UNITED STATES PATENT AND TRADEMARK OFFICE

APPLICATION NO.	FILING DATE	FIRST NAMED INVENTOR	ATTORNEY DOCKET NO.	CONFIRMATION NO.
10/780,072	02/17/2004	Michael L. O'Banion	0275Y-625COB	9473

Office Action Summary

DETAILED ACTION

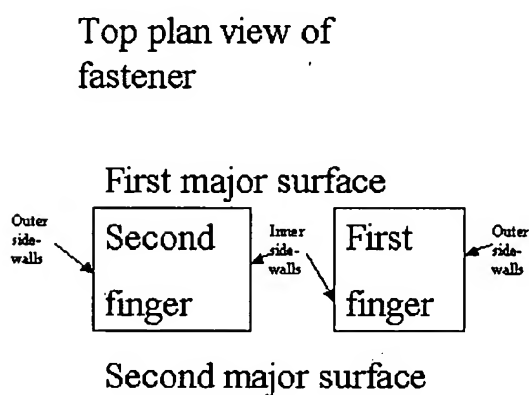
2. Examiner is assuming, based on an interview with attorney, that the major surfaces and sidewalls are arranged as below:
